CALIFORNIA COASTAL COMMISSION

RECORD PACKET COPY**Th 10a****STAFF REPORT AND RECOMMENDATION****ON CONSISTENCY DETERMINATION**Consistency Determination No. **CD-074-00**

FEDERAL AGENCY: CORPS OF ENGINEERS**DEVELOPMENT****LOCATION:**

Construction of dike to contain sediment generated by
landslide (Exhibits 2 and 3)

Figure 4-4. Alternative 2 – Containment Dike - 400 Feet Offshore

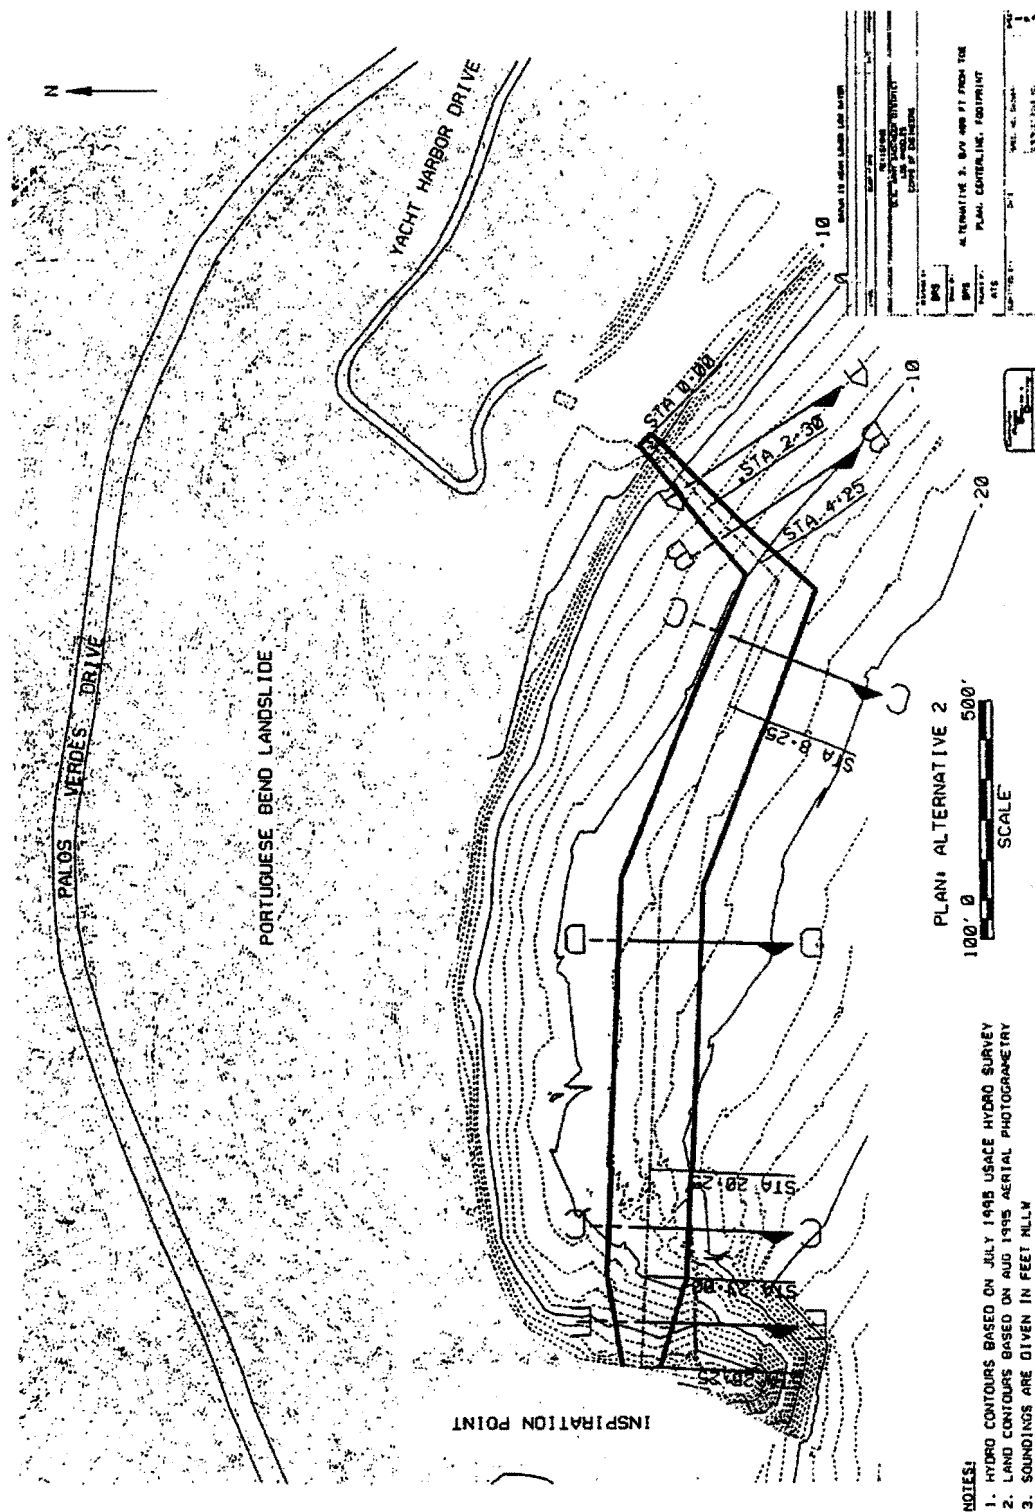
The Corps consistency determination allows for the construction of a dike offshore of Portuguese Bend cove, City of Rancho Palos Verdes. The Corps would construct the 2,500 foot-long dike, 400 feet offshore. The dike would have a maximum crest elevation of 24 feet above MLLW and would be in water depth 16 feet below MLLW.

The Corps' consistency determination did not adequately consider alternatives. First, the Corps did not consider landslide stabilization as a feasible method to reduce sedimentation. Second, the Corps did not consider alternative methods for enhancing marine resources that may have less of an adverse effect on marine resources. Third, and finally, the Commission believes that the "no-project" alternative may be a less damaging feasible alternative for the following reasons: 1) the Corps over estimated the amount of sediment produced by the landslide; and 2) there is some evidence that kelp habitat in Portuguese Bend may be restored naturally. Therefore, the Corps' alternative analysis is insufficient for the Commission to conclude that the proposed project is the least damaging feasible alternative as required by Section 30233(a) of the Coastal Act.

The Corps proposes to place the dike 400 feet offshore in order to place the structure in a geologically stable area. However, the Corps has not gathered enough geotechnical information to accurately make such a conclusion. The dike may be constructed landward of the toe of the slide or it may activate another slide. The Corps rejects additional geotechnical studies, because of the cost of studies. Without such information, the Commission cannot concur with the Corps' conclusion that the dike would be located in a geologically stable area, and thus, it cannot determine if the proposed dike is consistent with Section 30253 of the Coastal Act.

The Corps proposes to place the dike 400 feet offshore in order to place the structure in a geologically stable area. However, the Corps has not gathered enough geotechnical information to accurately make such a conclusion. In its geotechnical appendix, the Corps states that:

[T]he available information does not confirm that the near shore area is stable. Any structure proposed within 400 feet of the existing shoreline (out to a water depth of -10 to -20 feet MLLW) could be subject to displacement, either along an active slide, the reactivation of inactive slide planes, development of new sliding surfaces within the south dipping bedrock, or seaward movement of the landslide mass over the existing sea floor.³

Figure 4-5. Alternative 2 Cross-Sections

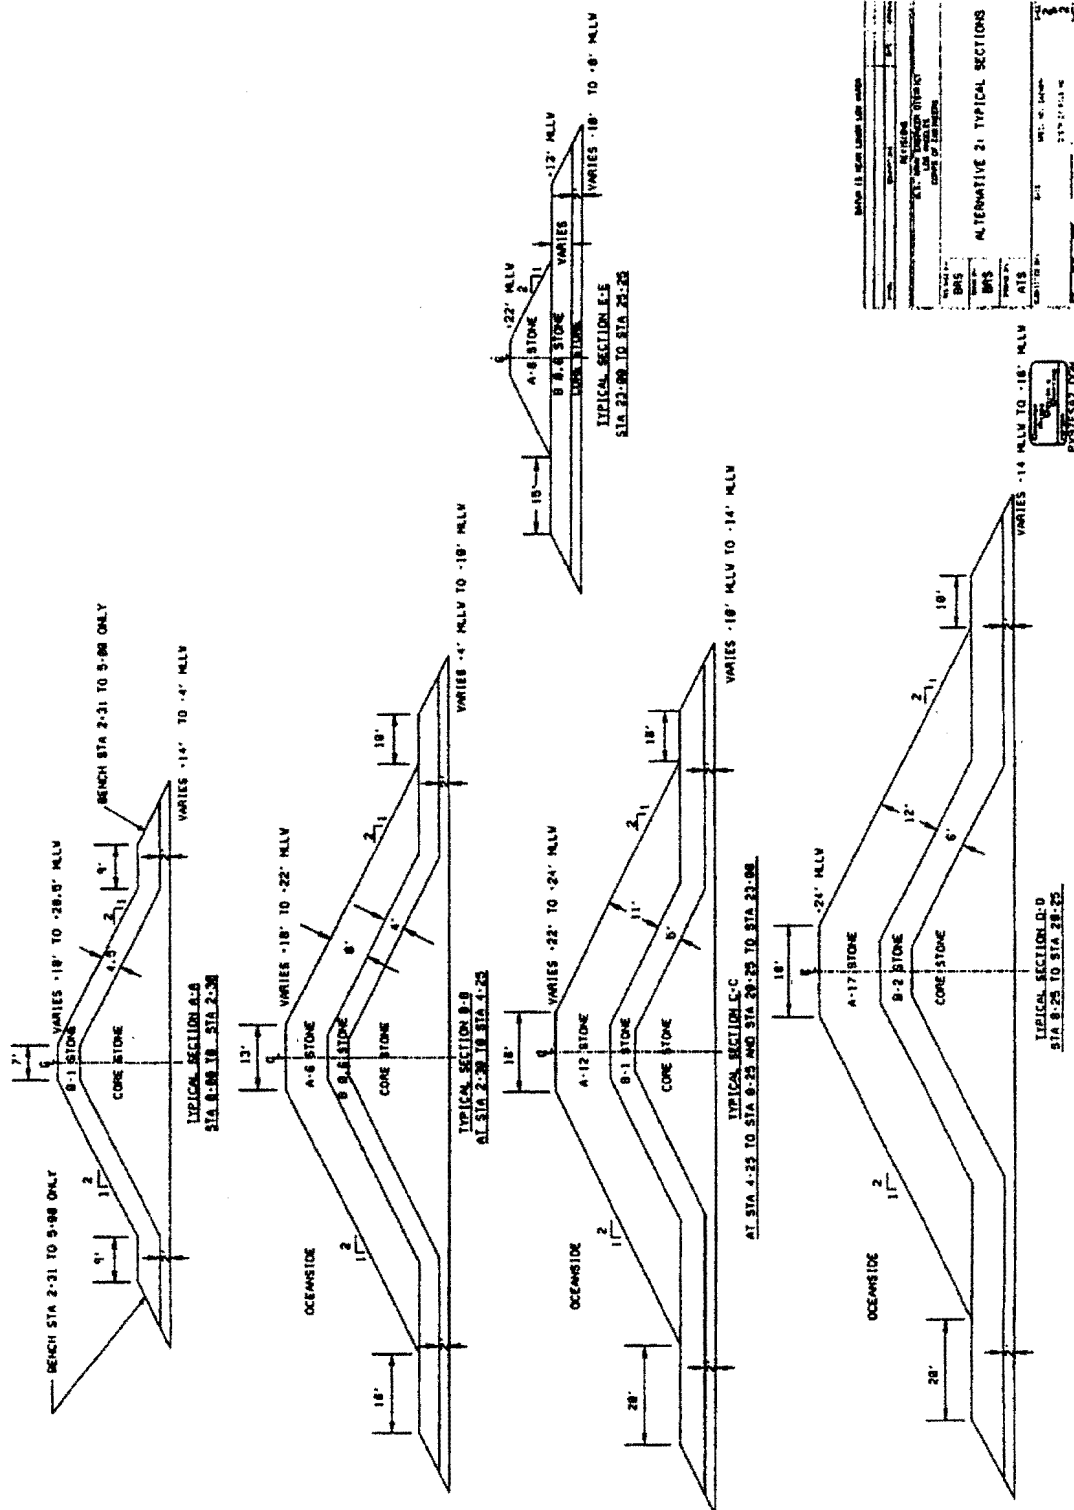
The proposed project would be located in a highly scenic area and would alter the visual character of the area, because it would not be subordinate to the natural setting. Therefore, the project is inconsistent with the Visual Policy (Section 30251) of the Coastal Act.

In its EIS, the Corps concludes that the project's visual impacts are not significant because of the offshore turbidity and scarred nature of the bluffs caused by the landslide. The Commission disagrees with this conclusion. The turbidity and bluff face are natural phenomenon that add to the dramatic nature of the area and do not necessarily distract from the visual resources. However, the proposed dike would be very different from the natural character of the area and would severely degrade the visual resource. Therefore, the Commission finds that the proposed project is inconsistent with the visual resource policies of the CCMP.

Figure 9. Boundaries of the three recent landslides that have contributed sediment to the nearshore waters off the coast of the Palos Verdes Peninsula. Adapted from ACOE 1996.

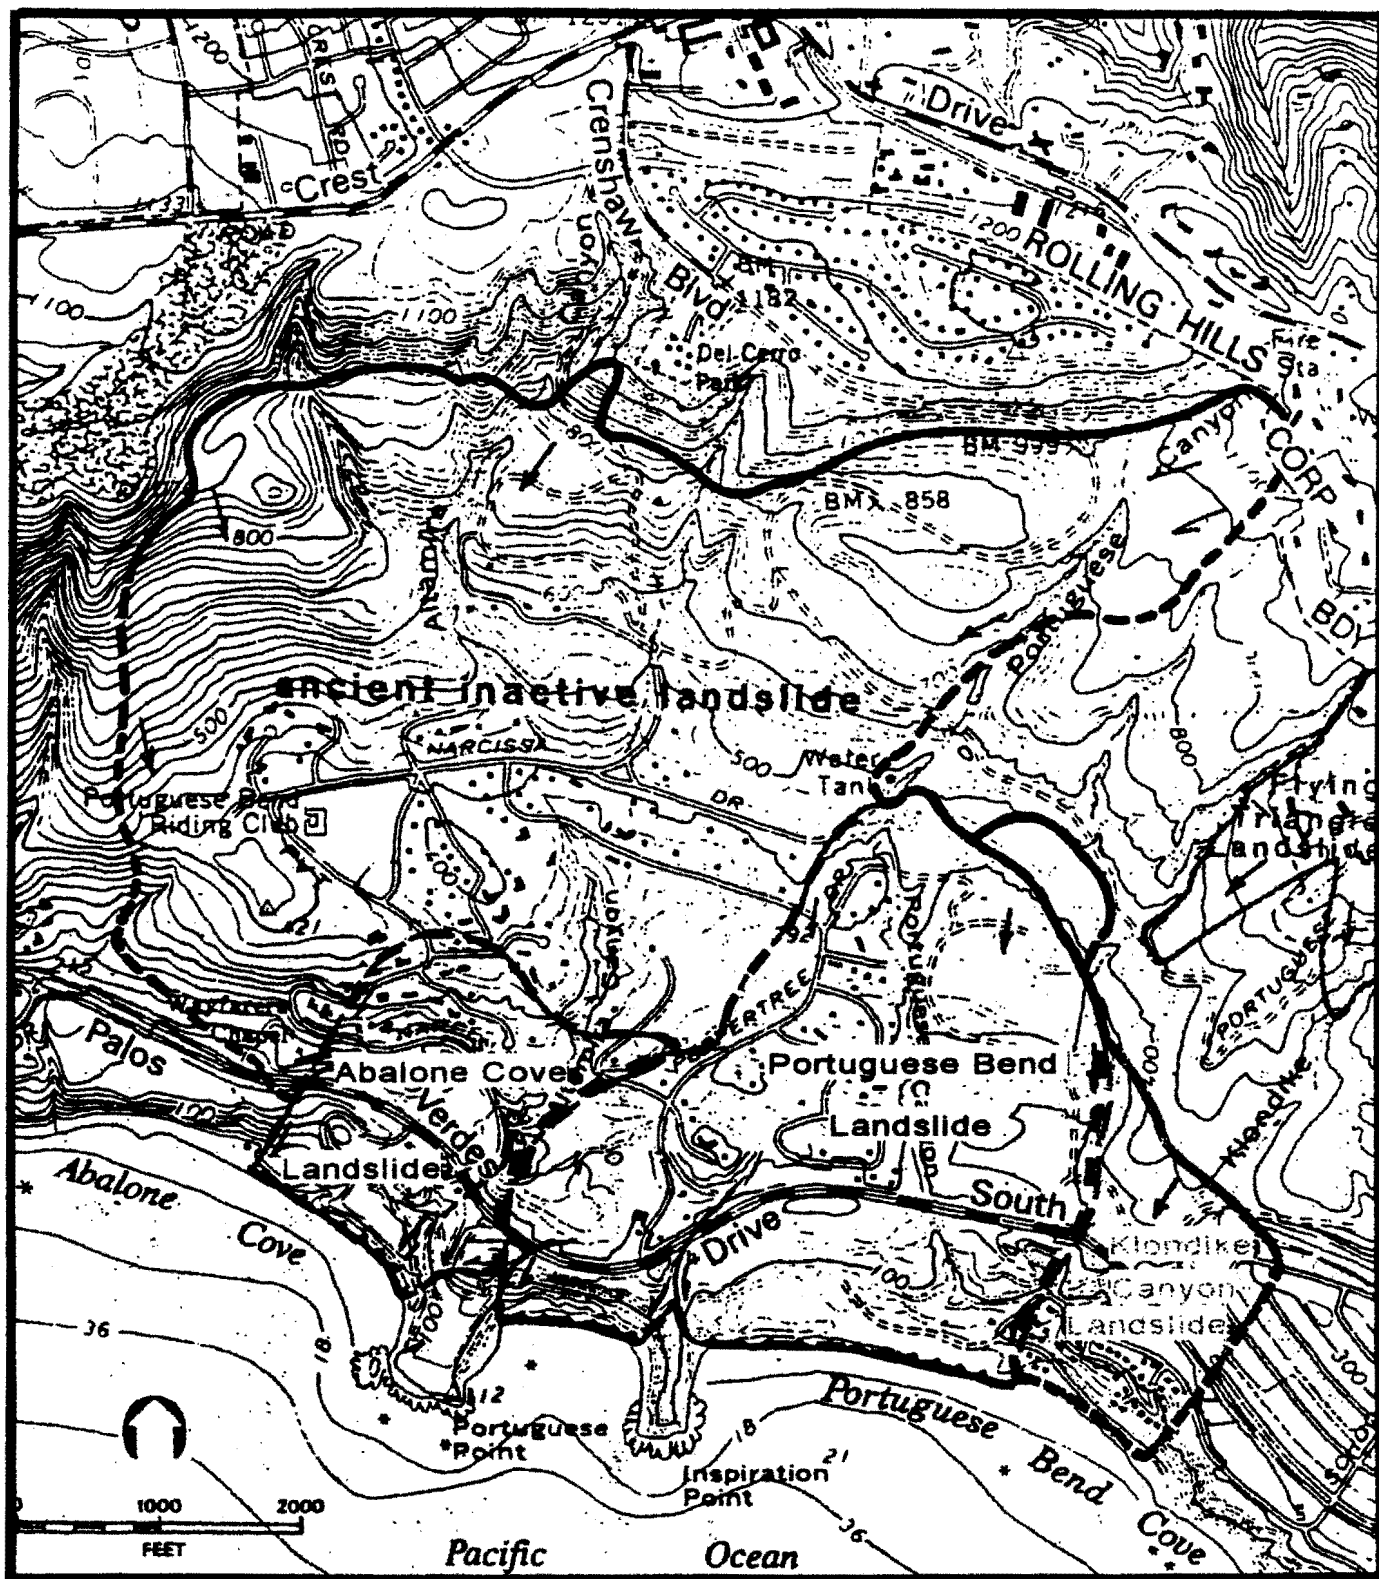
Portuguese Bend. In its feasibility study, the Corps states that the proposed project would capture most of the sediment from the Portuguese Bend landslide (Exhibit 4) and trap it on the inland side of the dike. The Corps assumes that if it constructs this dike, new sedimentation would be stopped and existing soft-bottom areas would erode back to hard-rock habitat. In its feasibility study, the Corps states that:

The Corps concludes that the Portuguese Bend landslide is the most significant source of sediment affecting this area and, by capturing this sediment, natural littoral processes would erode existing sediment from covered hard rock areas and allow kelp communities to be established in this area. These hard rock areas would provide habitat for giant kelp, which would be re-established in the area. However, most of the area seaward of the dike is too shallow to support a giant kelp forest. Giant kelp generally grows at a depth below 20 feet mean lower low water. According to the Corps' feasibility study, the area below 20 feet MLLW would take over 80 years before the hard rock habitat is re-exposed. Over that period of time, any number of factors could affect kelp habitat and prevent its restoration.

Changes in kelp bed canopy and distribution along the Palos V

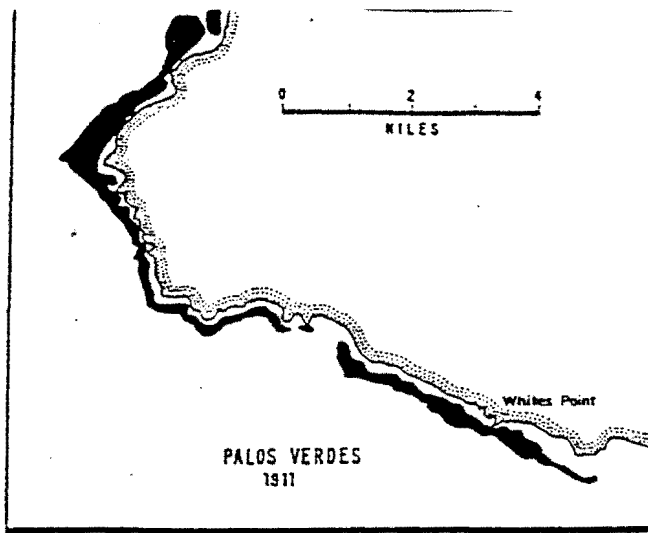
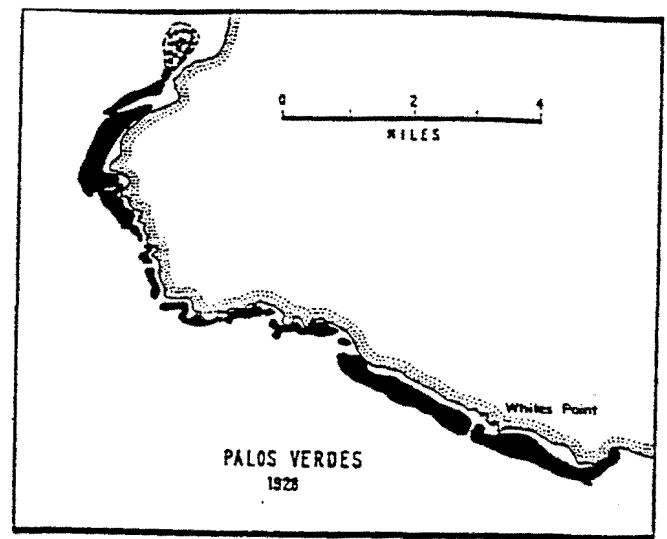
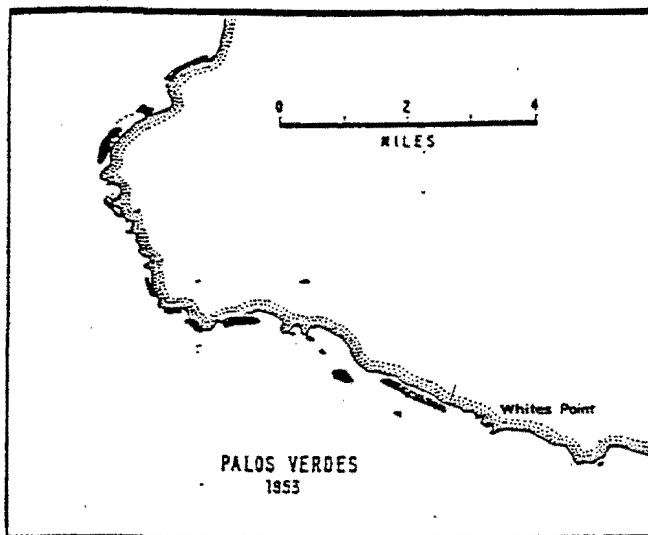
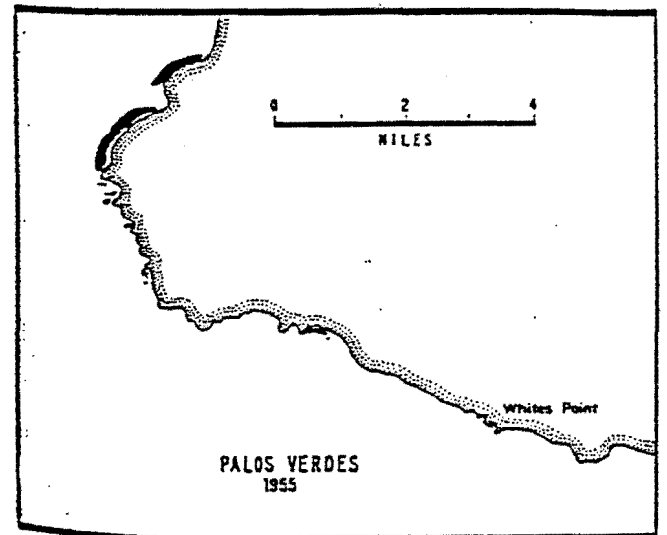
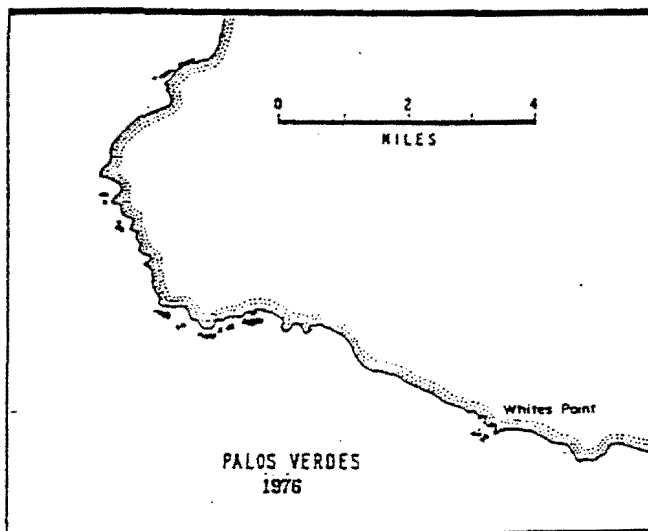
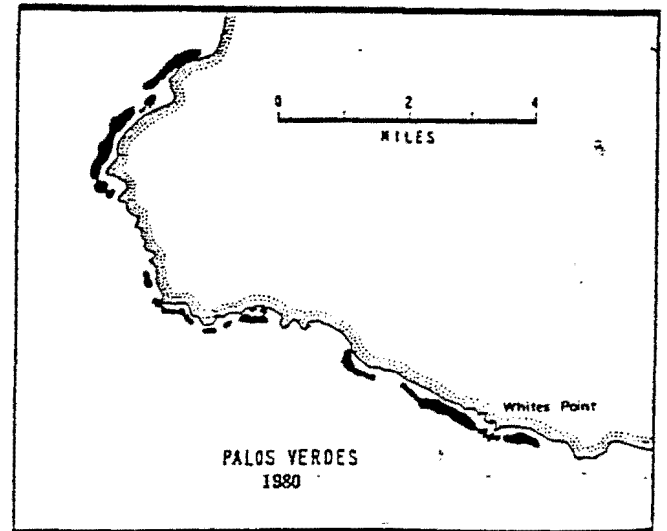
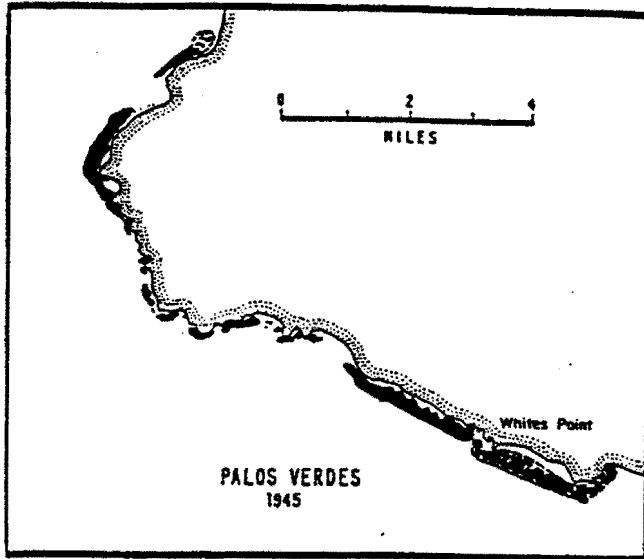
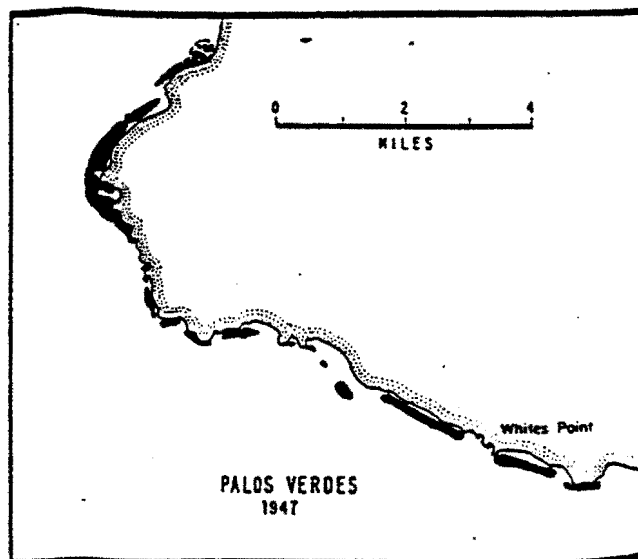
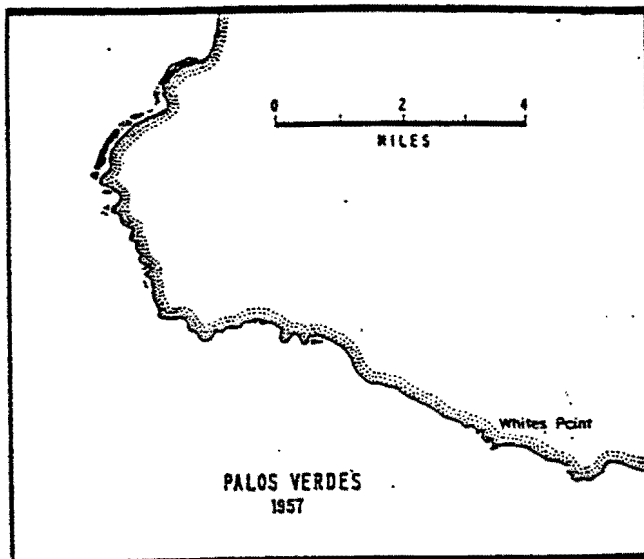
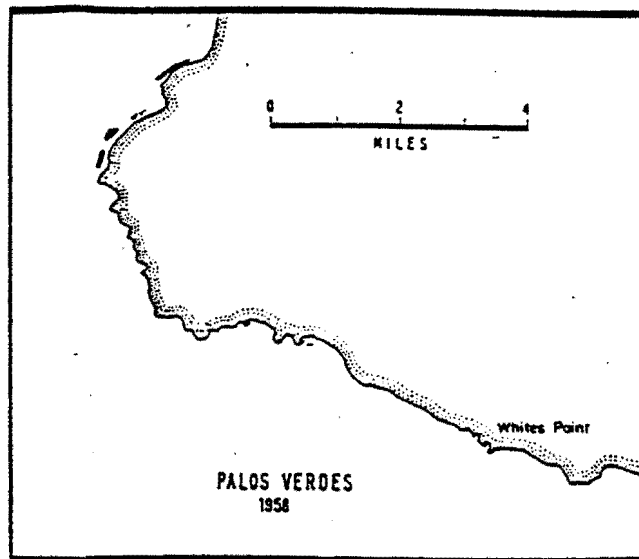
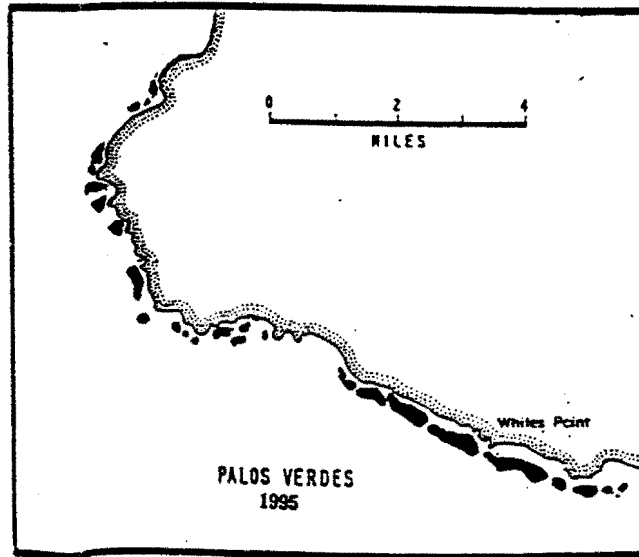
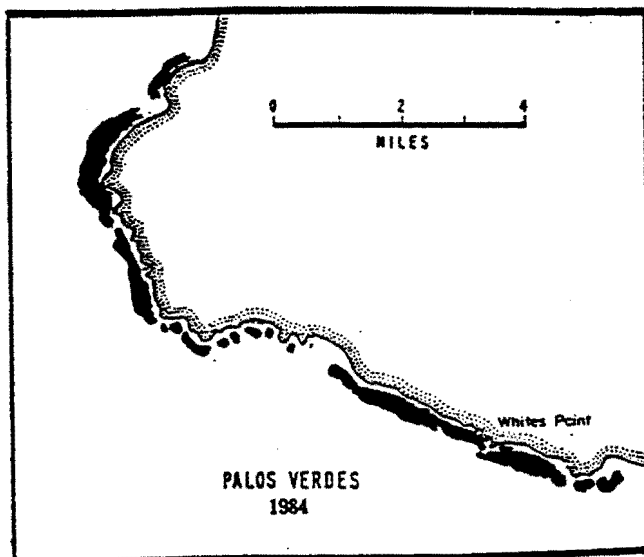
In addition, the Corps has not established that sedimentation from the landslide is the only factor that prevents kelp from growing in this area. In its draft Fish and

Wildlife Coordination Act report, the U.S. Fish and Wildlife Service (Service) presented convincing information that the kelp beds in the Palos Verdes Peninsula area had disappeared before re-activation of the landslide at Portuguese Bend (Exhibit 5). By 1956, when the landslide was re-activated there was almost no kelp in this area. The Service suggests that water pollution may have been the primary factor in the degradation of kelp habitat in this area. Thus, isolating sediment from the landslide may not remove the only factor that prevents the re-establishment of kelp in this area.
